**[Docket No. FAA-2025-0922; Project Identifier MCAI-2024-00650-R; Amendment
39-23163; AD 2025-20-10]**

Airworthiness Directives; Airbus Helicopters

ACTION: Final rule.

This AD applies to Airbus Helicopters Model EC120B helicopters, certificated in any category.

Figure 2 to paragraph (g)(1)(ii) - Inspection Areas of Tail Rotor Splined

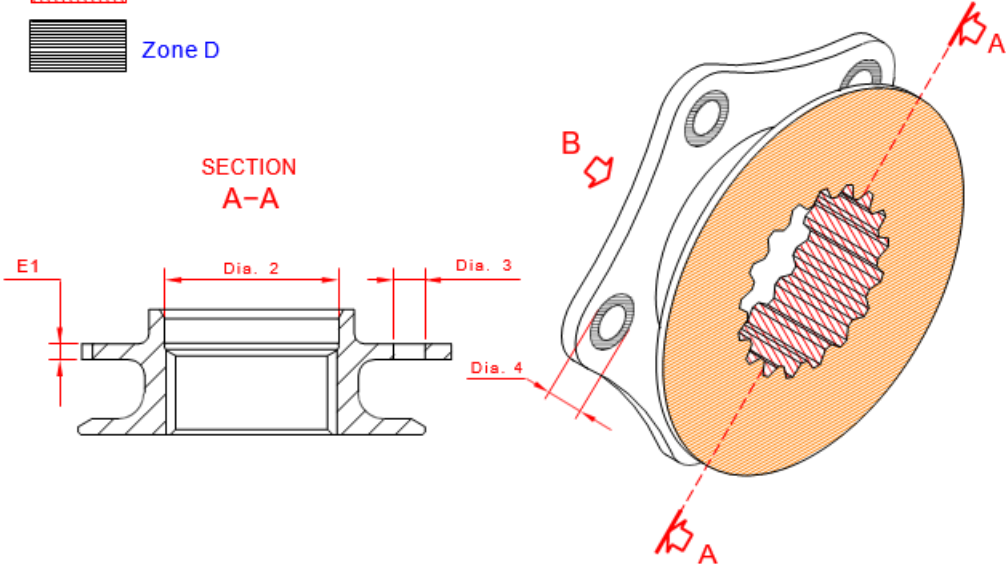
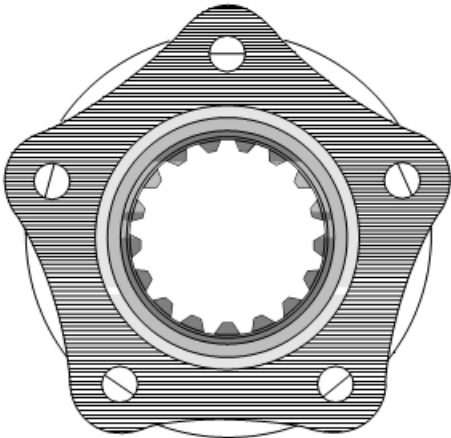
(ii) Inspect the TR splined flange for corrosion, impacts, fretting, wear, and a crack in the areas identified in Figure 2 to paragraph (g)(1)(ii) of this AD. If the condition of the part (including corrosion, impacts, fretting, wear, or cracks) exceeds the criteria as

specified in Figure 1 to paragraph (g)(1)(ii) of this AD, before further flight, remove the splined flange from service and replace with an airworthy part.

Location as specified in Figure 2 to paragraph (g)(1)(ii) of this AD	Maximum damage, which causes replacement (E1, Dia. 2, Dia. 3, and Dia. 4 are shown in Figure 2 to paragraph (g)(1)(ii) of this AD)
Zone A	Scratch depth > 0.2 mm (0.008 in.). Crack. E1 < 2.75 mm (0.108 in.). Dia. 3 > 6.02 mm (0.2371 in.). Dia. 2 > 33.03 mm (1.3004 in.).
Zone B	Touch-up depth > 0.1 mm (0.004 in.). Crack.
Zone C	Crack. Scratch depth > 0.2 mm (0.008 in.).
Zone D [Dia. 4 = 14 mm +/- 0.1 mm (0.548; 0.555in.)]	Touch-up depth > 0.1 mm (0.004 in.). Crack. E1 < 2.75 mm (0.108 in.).
